SH58 & SH59 Porirua Region

Existing Road - Safe System Audit Report

Prepared for Waka Kotahi

REVISION 1 - MARCH 2023

Figure 5.3-1 – Poles and railway hazard

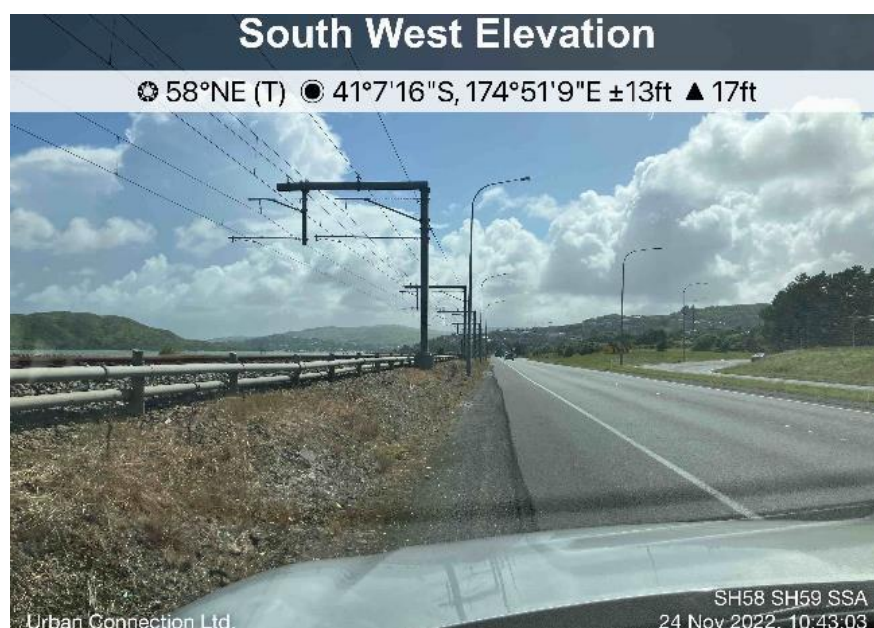
Prominent crash type		Against non-frangible objects
Probability	Unlikely	Straight alignment and wide shoulders
Severity	Fatal	Impact speeds > 90 km/h

1. *Identify roadside hazards and either remove, relocate, underground, or protect with roadside barriers;*
2. *Consider opportunities for additional roadside barrier protection by extending the length of existing barriers (during replacement) to close off roadside hazards further.*

Safety Engineer: *There will be a reduced risk exposure due to change in traffic patterns and reduction in traffic volumes since the opening of Transmission Gully. All recommendations have been noted and will be assessed and prioritised along with all other regional safety projects and implemented in accordance with allocated funding.*

Figure 5.3-5 – Intersection layout and conflict angles at the SH59/SH58 roundabout

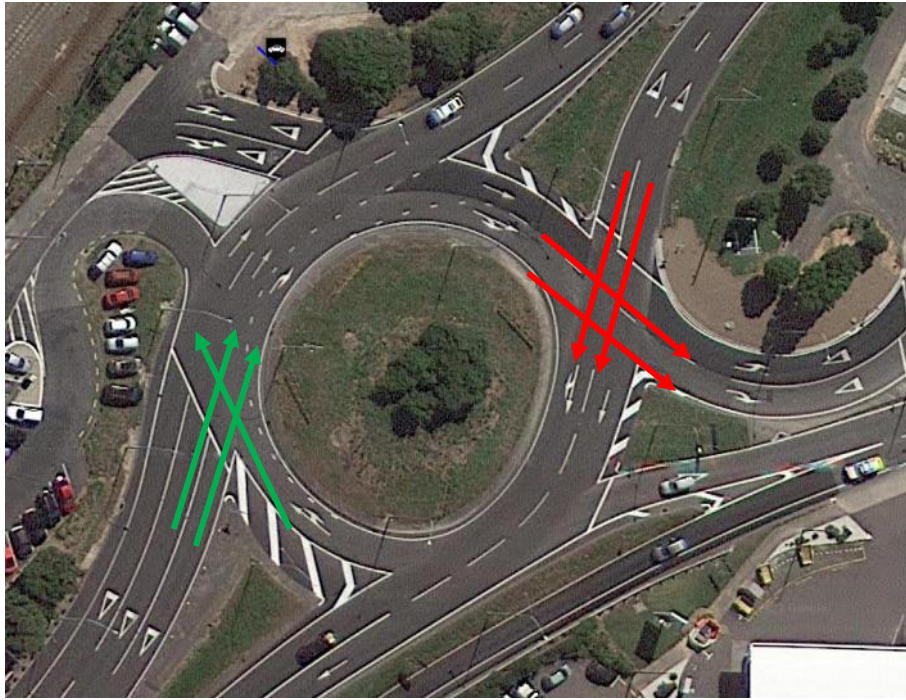
The observed safety hazard could be a result of an insufficient entry deflection on the north side of the roundabout. For instance, it can be observed that the conflict angle between approaching southbound vehicles and others on the circulating carriageway is somewhat close to 90 degrees, likely to generate high impact angles (refer to red arrows in Figure 5.3-5). This is unusual for a typical roundabout layout. In turn, high impact angles are likely to result in more severe crashes. In contrast, the southern approach generates lower impact angles, likely to result in less severe crashes (refer to green arrows below).

Prominent crash type		Side-impact at high impact angles
Probability	Likely	Relatively high impact speeds and high traffic volumes
Severity	Serious	Impact speeds of 50-60 km/h

Probability Rating:	Severity Outcome Rating:
<i>The probability of a crash is Likely</i>	<i>Crashes are likely to be Serious</i>
Design Team Response: <i>N/A</i>	
Safety Engineer: <i>There will be a reduced risk exposure due to change in traffic patterns and reduction in traffic volumes since the opening of Transmission Gully. This may be further reduced with the implementation of the corridor speed management plan. All recommendations have been noted and safety improvements at this roundabout will be assessed and prioritised along with all other regional safety projects and implemented in accordance with allocated funding.</i>	
Client Decision: <i>We note that the auditor acknowledges the issues identified pre-date Transmission Gully. Recommendations are noted and we will seek funding to implement any relevant changes, subject to prioritisation alongside other highway safety needs.</i>	
Action Taken: <i>Recommendations are noted, and we will seek funding to implement any relevant changes, subject to prioritisation alongside other highway safety needs.</i>

Figure 5.3-6 – Intersection layout and conflict angles at the Whitford Brown intersection

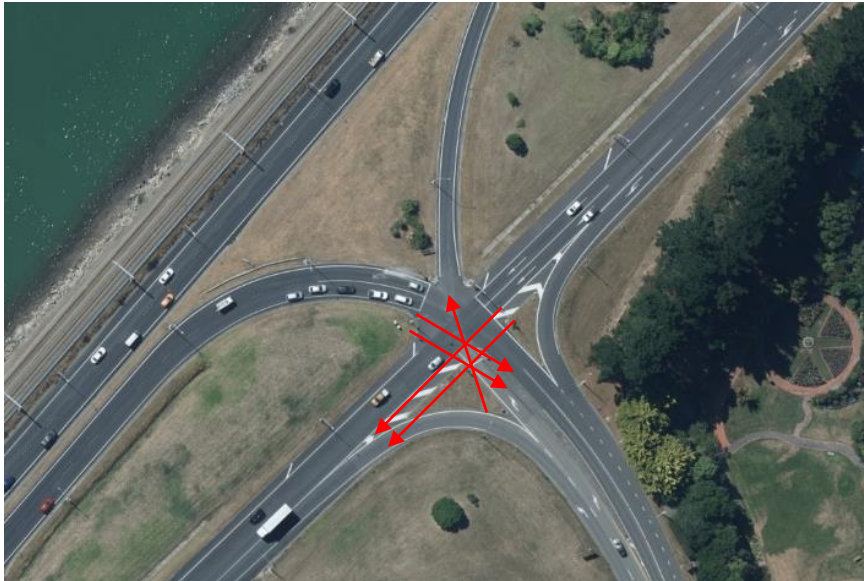
The SH59/Whitford Brown Avenue is signalised. The posted speed limit through the intersection is 100 km/h, with similar expected operating speeds. The layout consists of right-turn movements in and out of Whitford Brown Avenue at 90-degree angles with SH59. Therefore, side-impact crashes involving right-turning vehicles in this locality are expected to result in high impact angles (refer to Figure 5.3-6). This configuration does not align with Safe System principles.

Furthermore, rear-end crashes are expected to occur at this intersection due to braking when signals change from the green to red phase. This is a common crash type in high-speed areas with traffic signals. It is noted that over 50% of the crashes at this intersection are of the rear-end type. Therefore, the probability is assessed as 'Likely'. This crash type is expected to result in low impact angles. However, a 'Serious' outcome could occur given the potential for high impact speeds of 100 km/h.

Prominent crash type		Rear-end collisions
Probability	Likely	Traffic signals in a high-speed area with high traffic volumes
Severity	Serious	Impact speeds > 90 km/h

Safety Engineer: This intersection is included for safety investigation and improvements during the current National Land Transport Plan. Design work is in progress and in consultation with Porirua City Council. There will be a reduced risk exposure due to change in traffic patterns and reduction in traffic volumes since the opening of Transmission Gully. This may be further reduced with the implementation of the corridor speed management plan. Further major long-term improvements will be assessed and prioritised along with all other regional safety projects and implemented in accordance with allocated funding.

Figure 5.4-2 – Visibility at the Plimmerton Roundabout

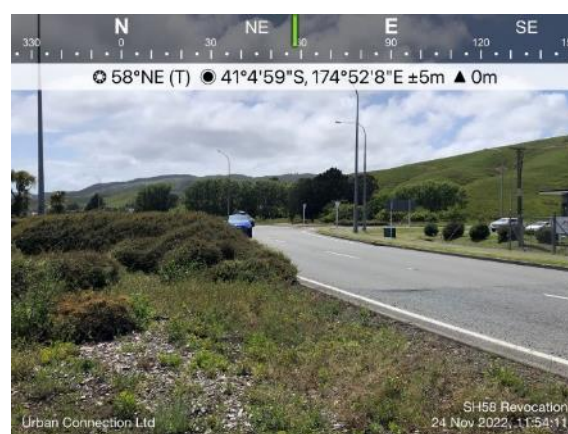
- An existing crossing just south of the Plimmerton Roundabout has intervisibility between pedestrians and vehicles obscured by vegetation (refer to Figure 5.4-2), increasing the likelihood of crashes against vulnerable road users (VRU);

Prominent crash type		Against vulnerable road users (pedestrians)
Probability	Likely	Long crossing distance, long distance between facilities, no mid-block facilities, short signal pedestrian phase, no TGSi
Severity	Fatal	Impact speeds ≥ 50 km/h

Probability Rating:	Severity Outcome Rating:
<i>The probability of a crash is Likely</i>	<i>Crashes are likely to be Fatal</i>
Design Team Response: N/A	
Safety Engineer: <i>There will be a reduced risk exposure due to change in traffic patterns and reduction in traffic volumes since the opening of Transmission Gully. This may be further reduced with the implementation of the corridor speed management plan. All recommendations have been noted and further long-term pedestrian improvements will be assessed and prioritised along with all other regional safety projects and implemented in accordance with allocated funding.</i>	
Client Decision: <i>We note that the auditor acknowledges the issues identified pre-date Transmission Gully. The character of this corridor varies significantly between the two roundabouts and the crossing facilities need to be carefully considered in context. All recommendations have been noted and further long-term pedestrian improvements will be assessed and prioritised along with all other regional safety projects and implemented in accordance with allocated funding.</i>
